**This paper provides additional information and justification regarding
document GRE/2026/6**

**I. Proposal for a Supplement to the 06, 07, 08 and 09 series of
amendments to UN Regulation No. 48**

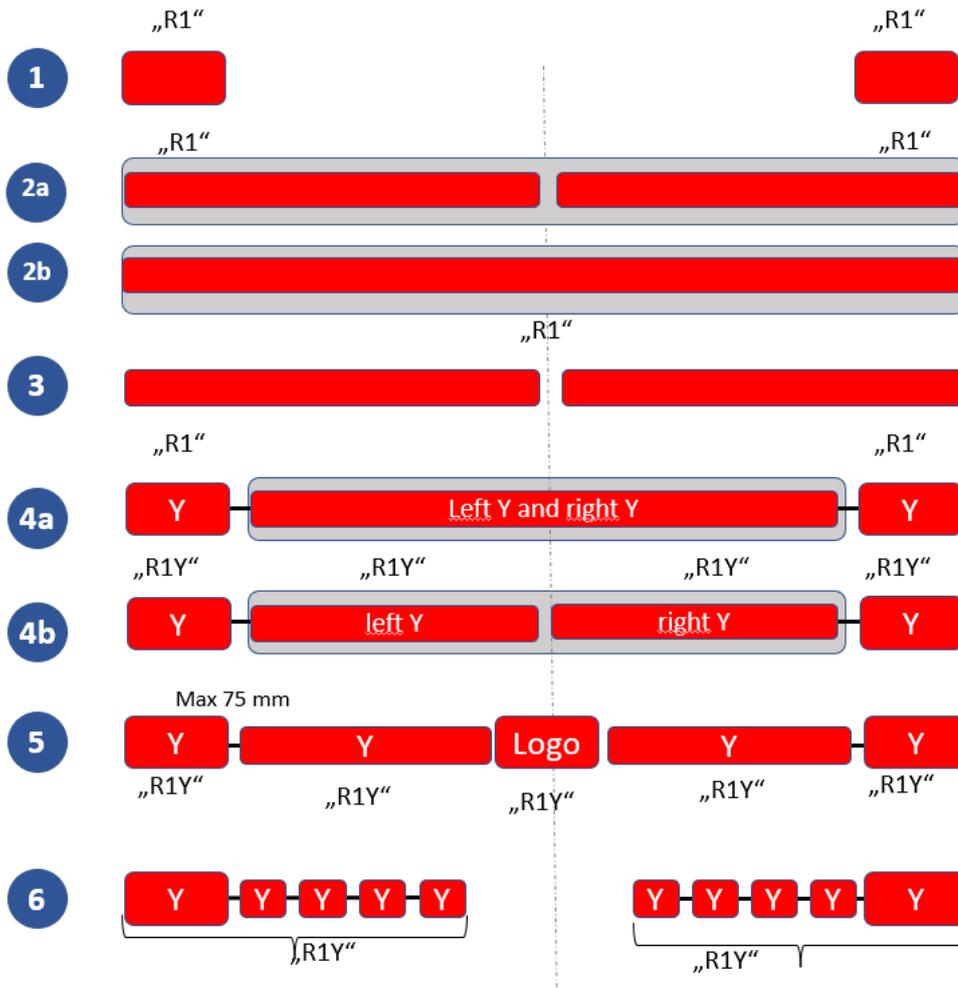
- “4.8.1.3. In case of a lamp (function) using light sources which are subject to more than one of the conditions prescribed in paragraph 4.8., the photometric measurements shall be made separately, in accordance with each applicable condition(s) set forth in paragraph 4.8..

All separate measurement results shall be added together.

The test laboratory may require from the applicant samples allowing to ~~supply~~ **operate** the different light source(s) separately.”
